Re: **121 E. Wilson Street – Alteration to Approved Plans**

121 E. Wilson Street

02/13/2023 URBAN DESIGN COMMISSION REVIEW

4 NE ELEVATION - BW - CURRENT
1/16" = 1'-0"

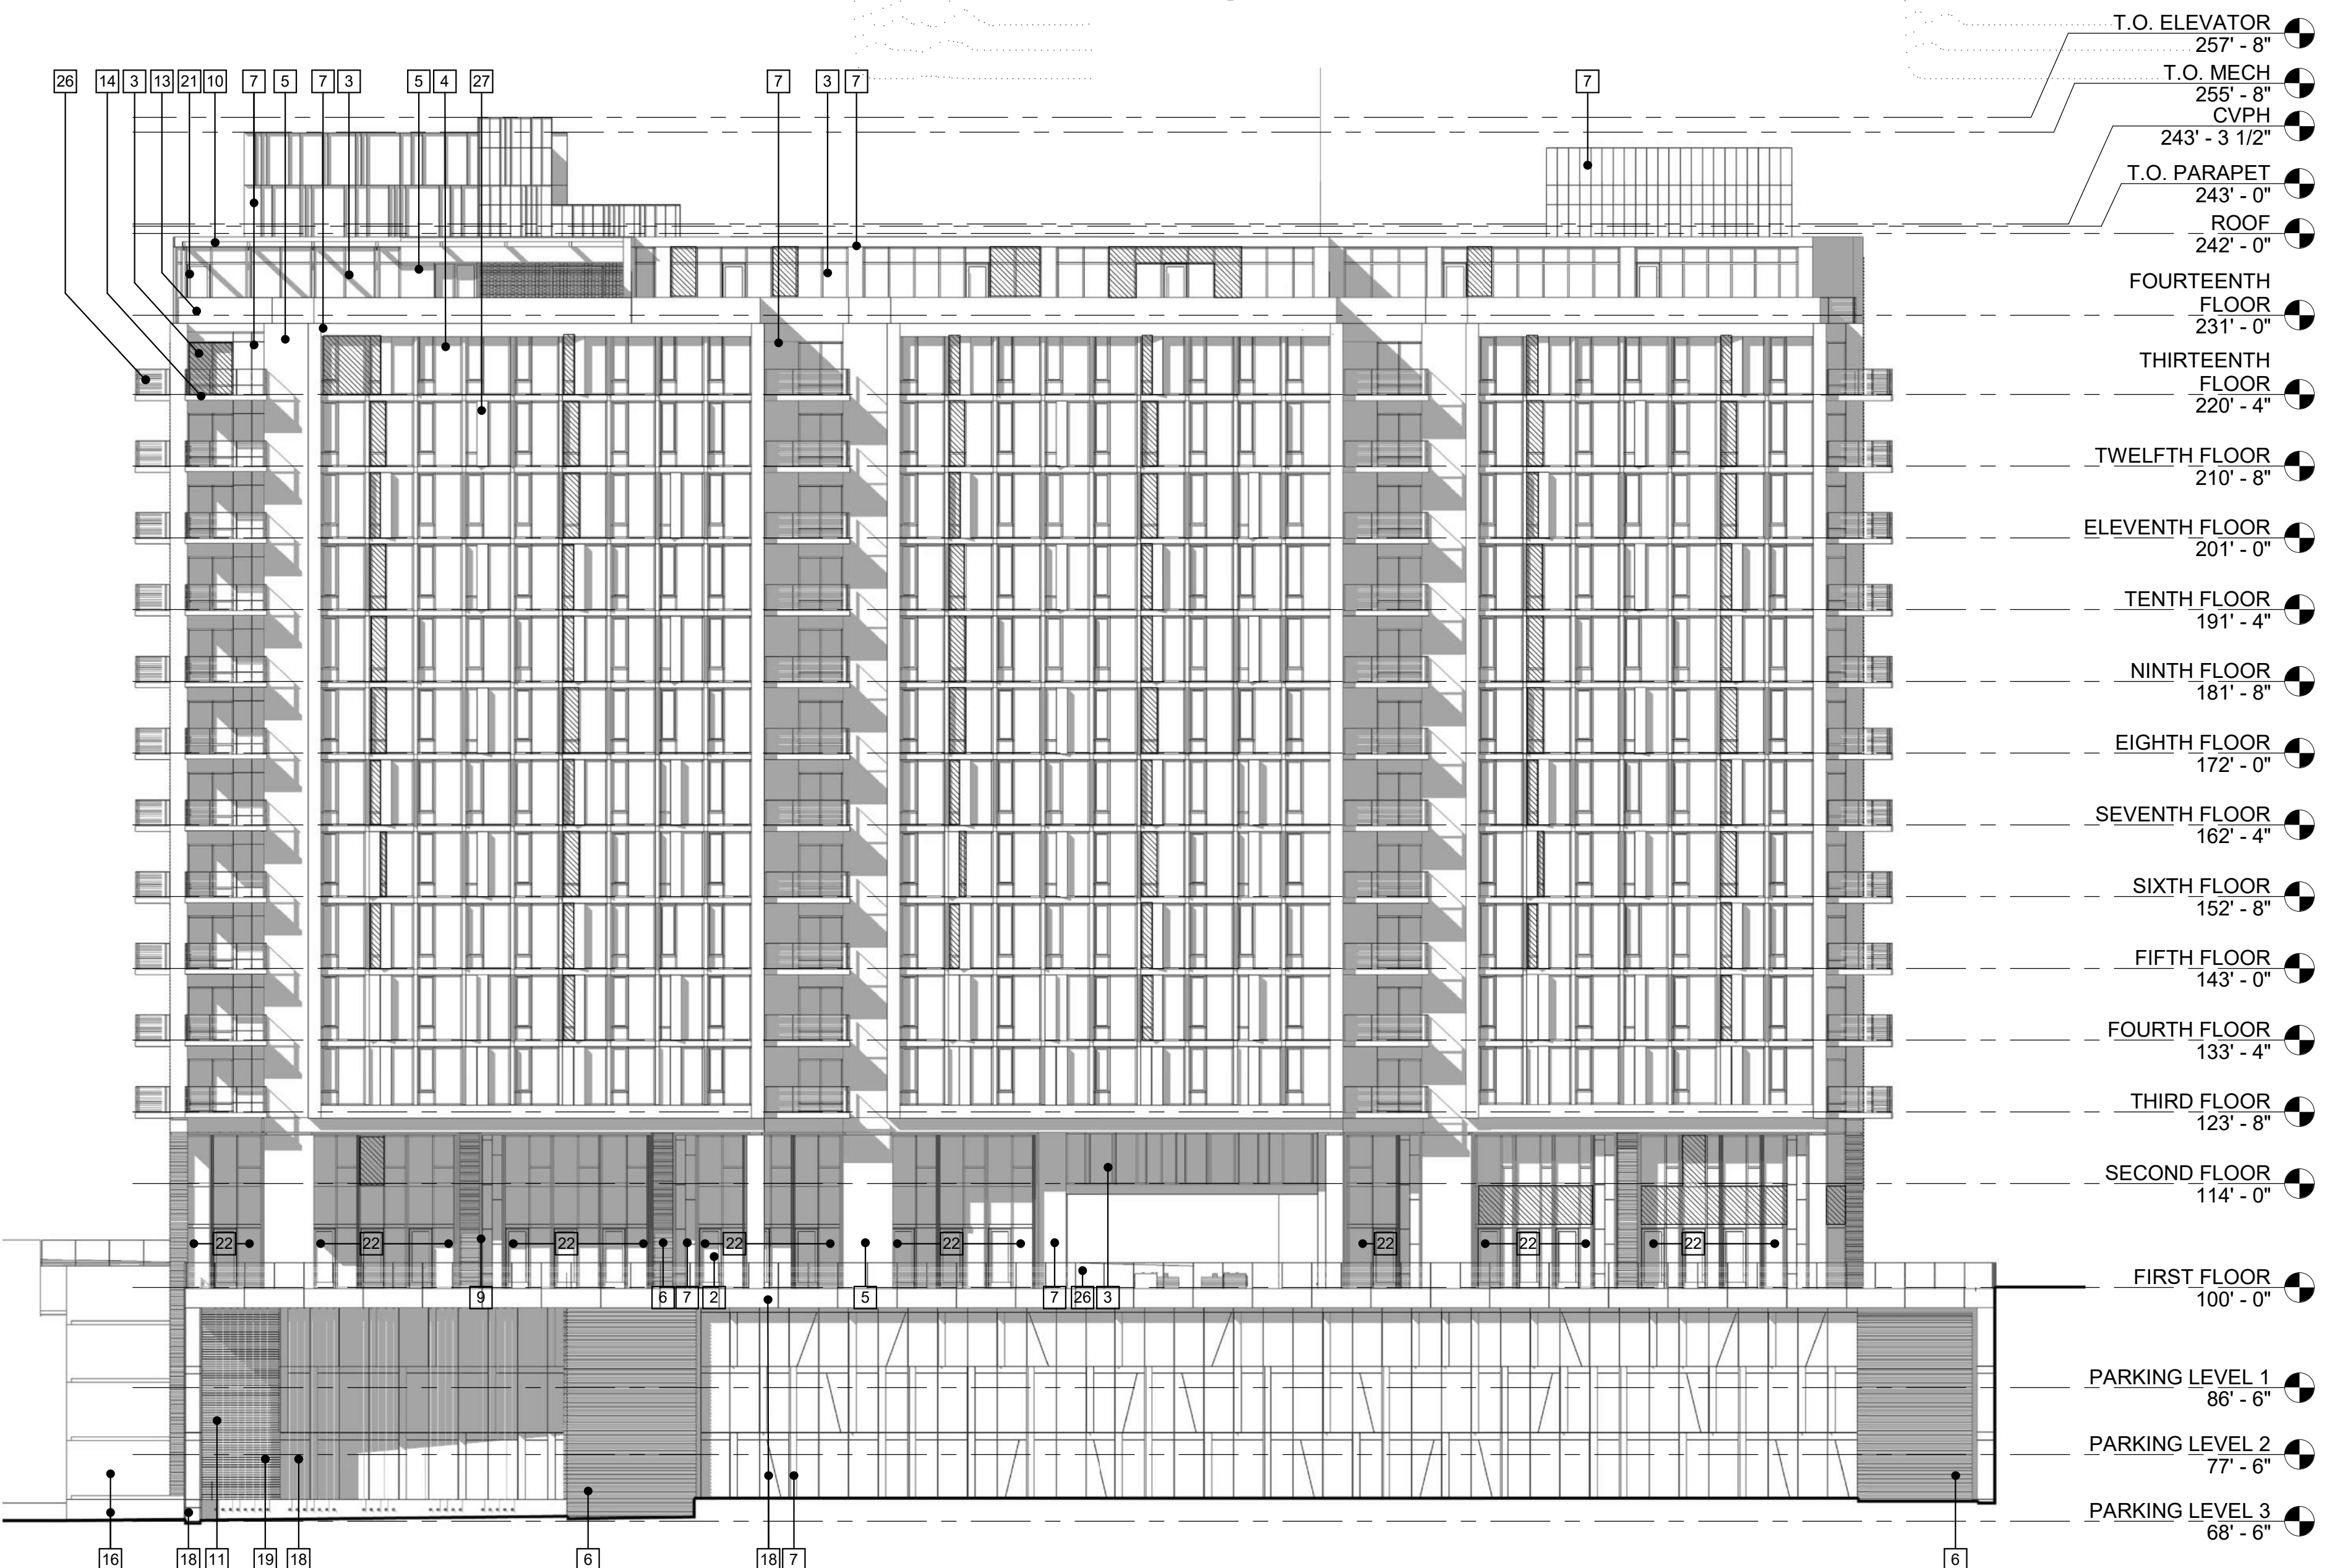
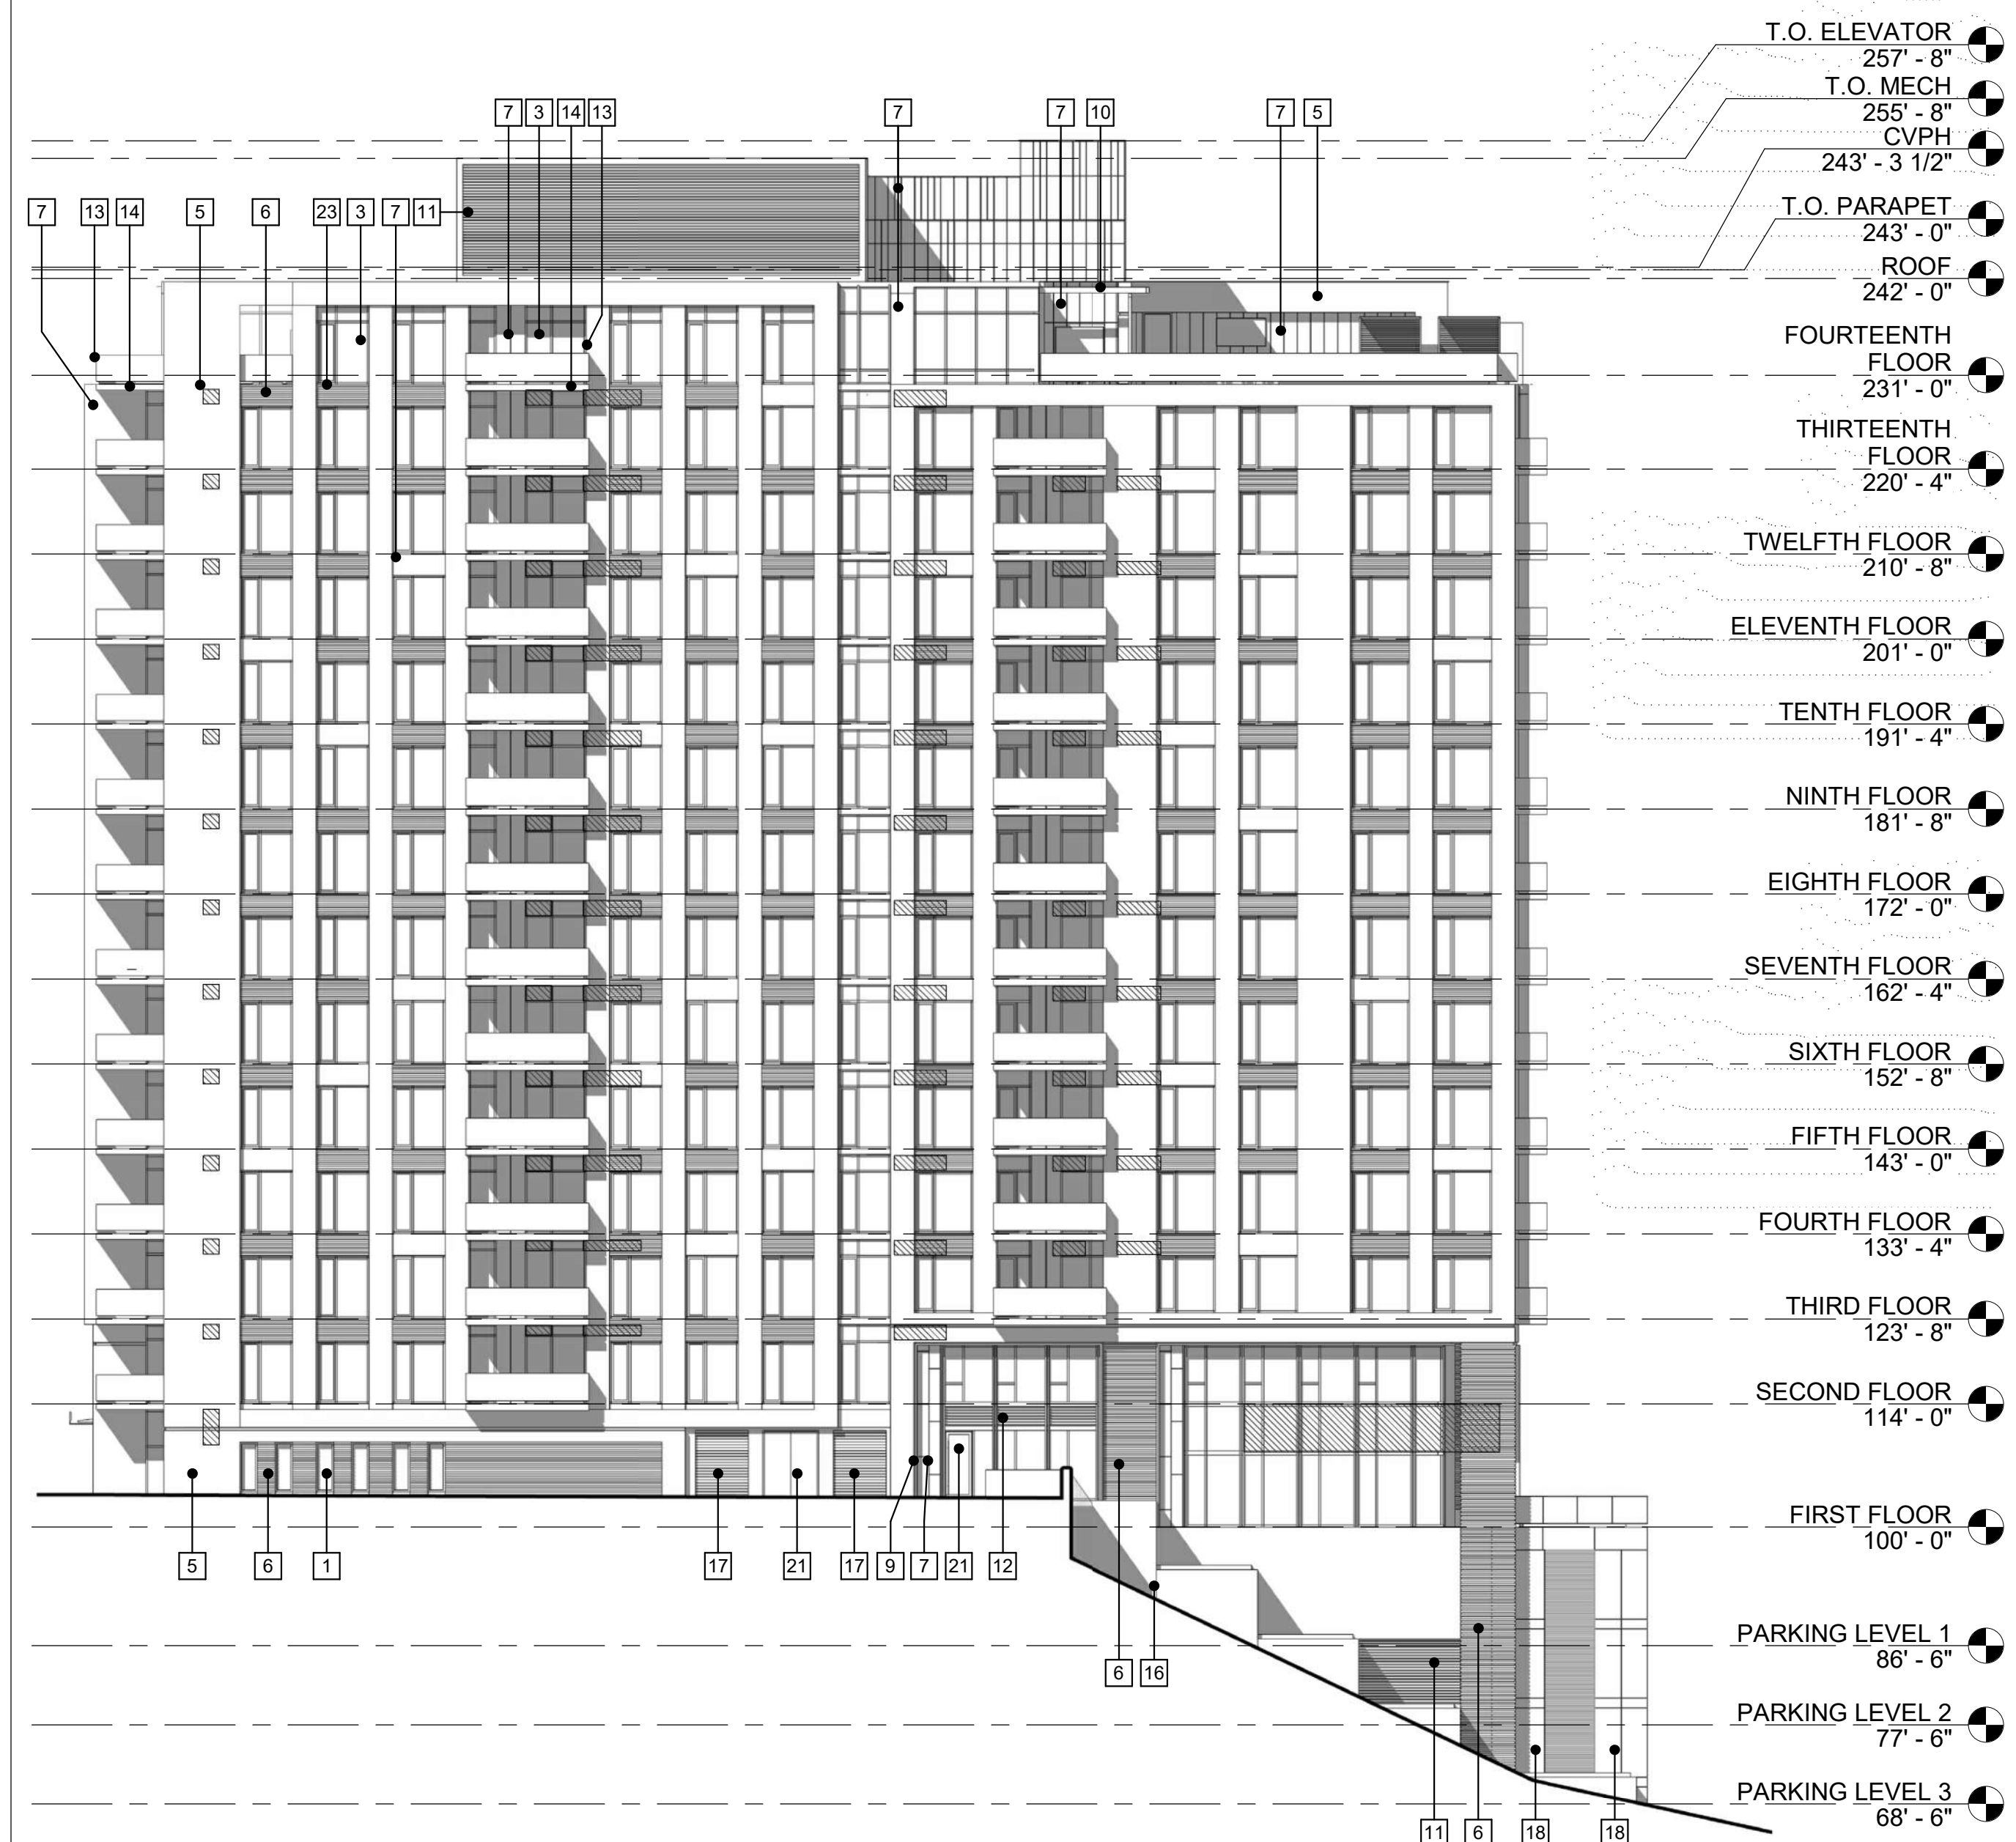
- The most significant change is a shift in the form and arrangement of the Concealed Fastener Metal Panels that occur on the Wilson St and John Nolen Dr facade.

- Previously the metal panels were scattered “randomly” across the facade while their quantity was reduced as you moved up the facade. The accent within the metal panels was a pleated form that pushed inward.

- Currently the metal panels are clustered around internal demising walls and where heat pumps are located along the exterior. The randomness is reintroduced by increasing the frequency of the pleat accent, which is now a folded accent. The metal panels fold outwards in either a left or right justification in a composed pattern. Similar to the original concept, the metal panels become less dense as they move up the facade.

**BUILDING FACADE
LIGHTING**

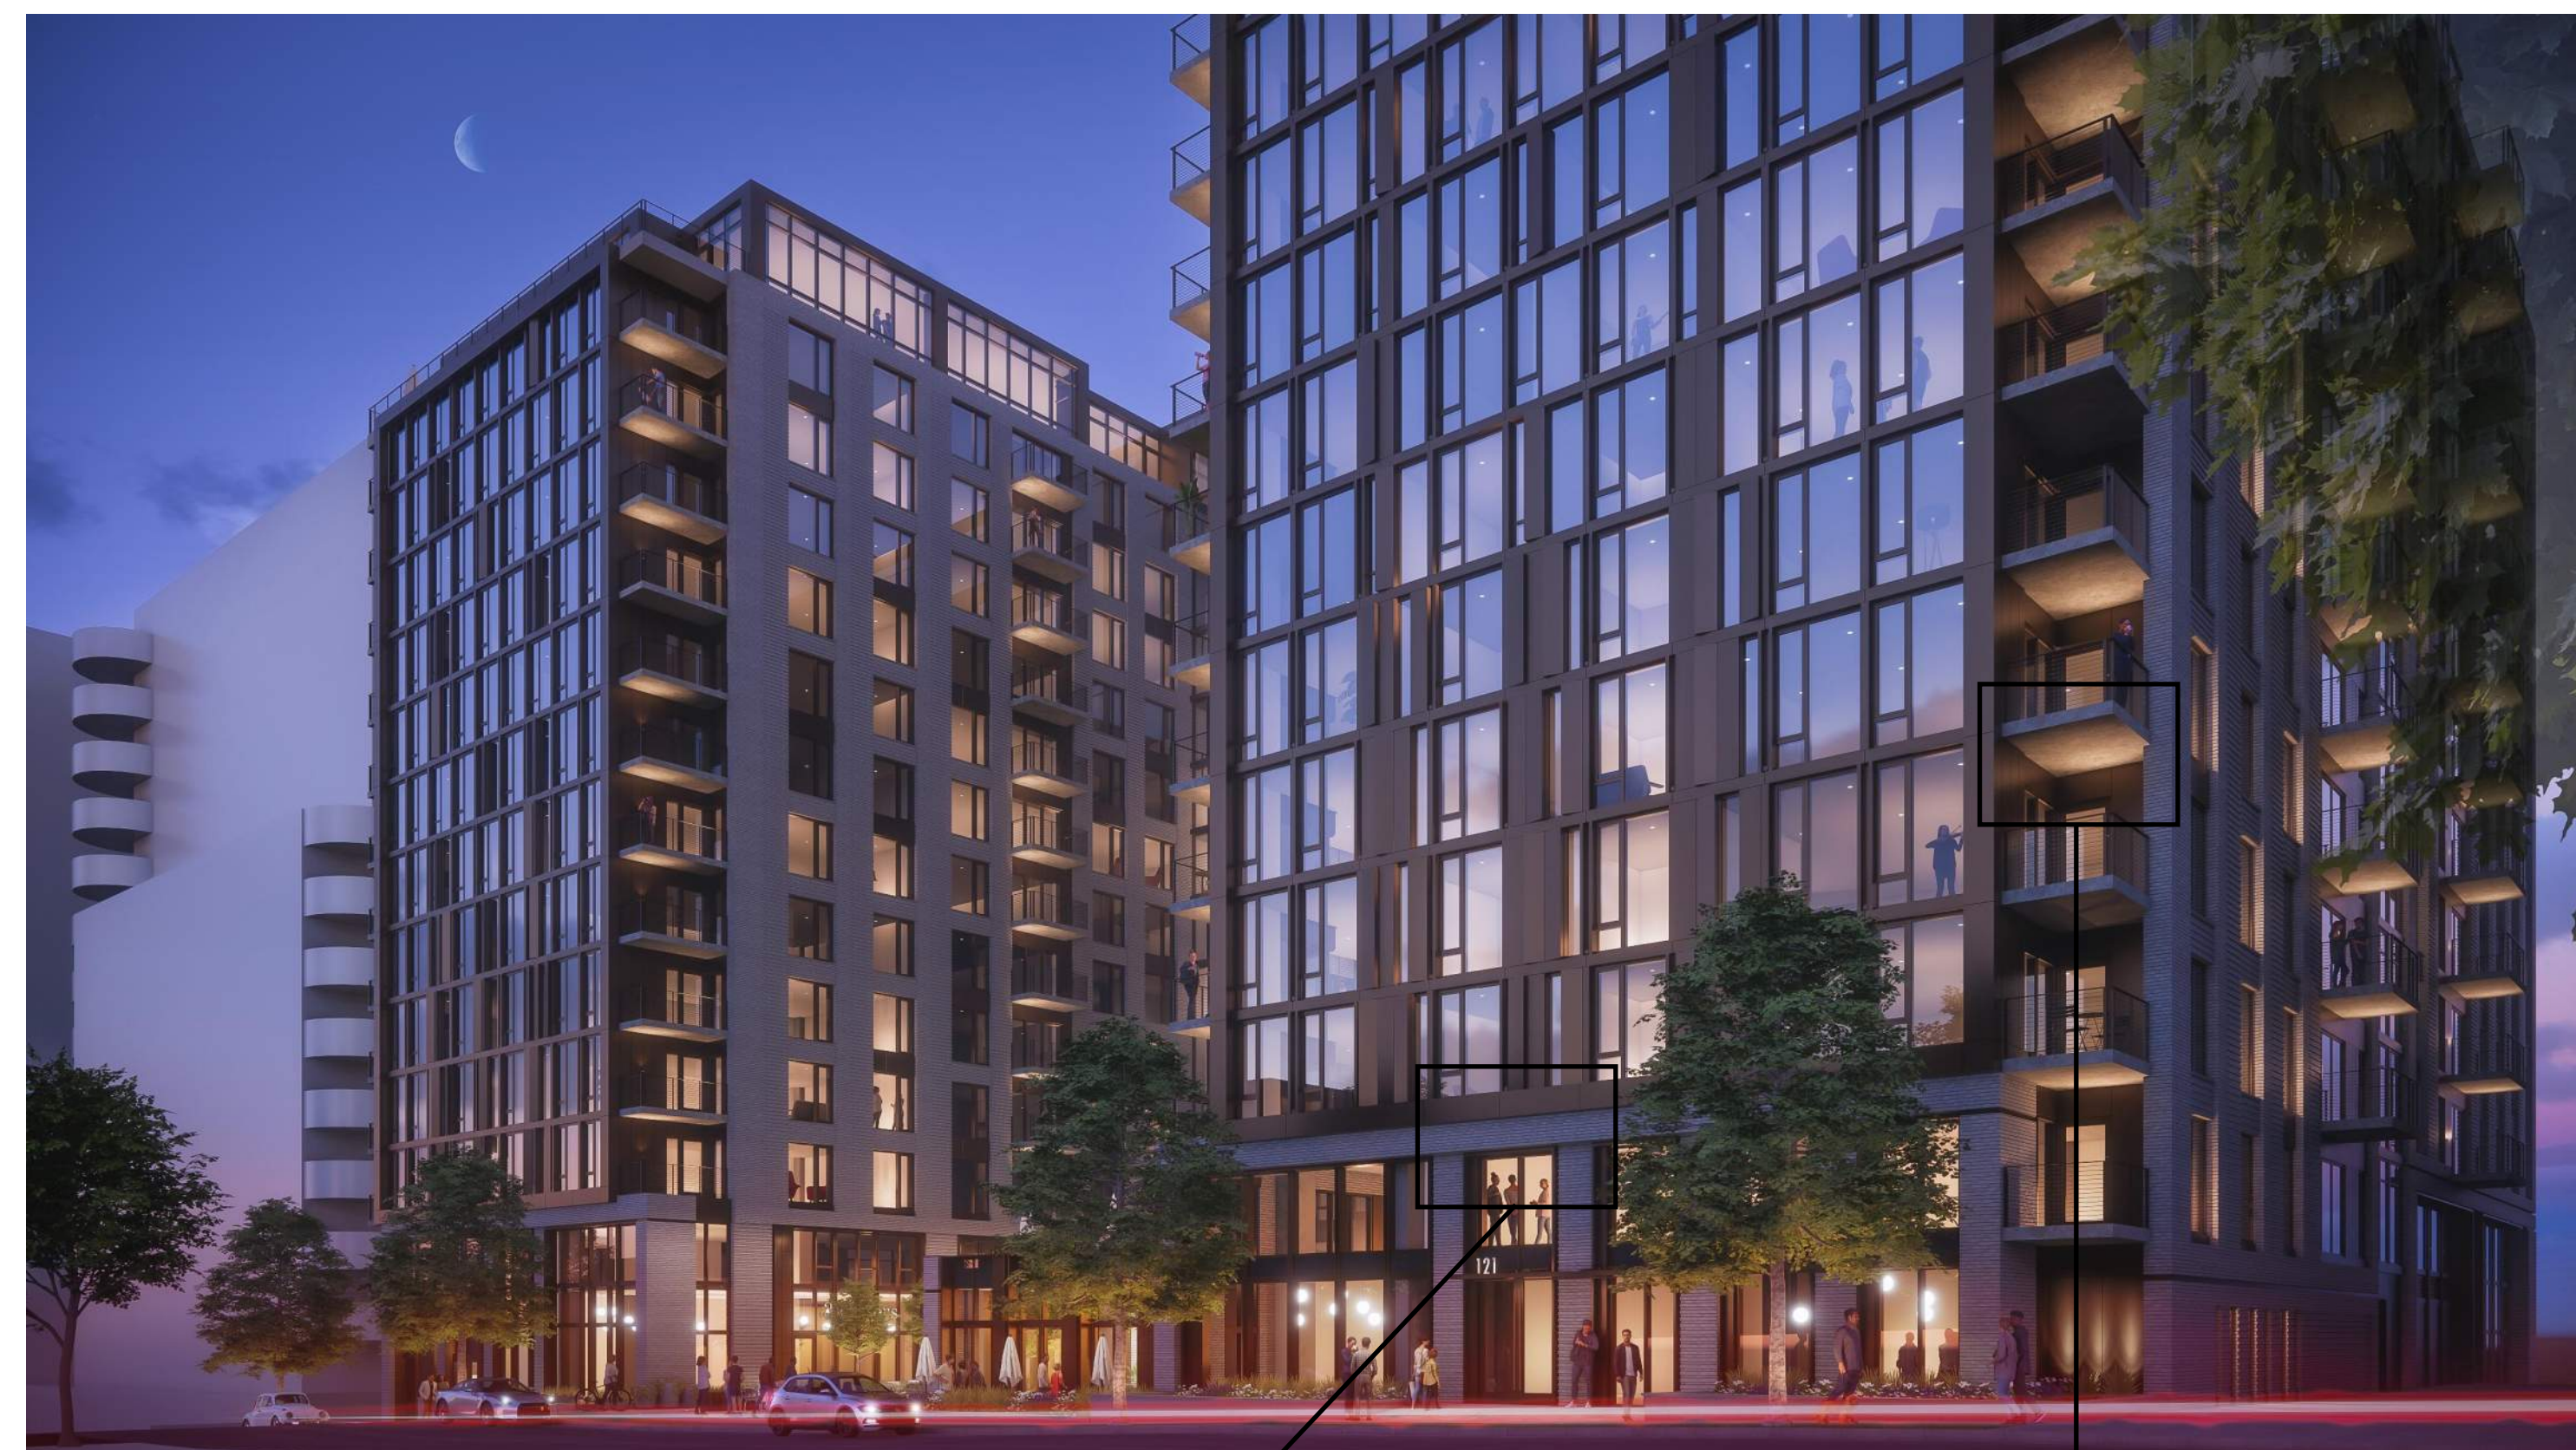
- The façade lighting elements illuminating the metal panels have been removed to ensure compliance with the Dark Sky Ordinance, reduce the potential of unwanted light bleeding into units, and eliminate potential maintenance issues with snow and water accumulation with inset light fixtures.
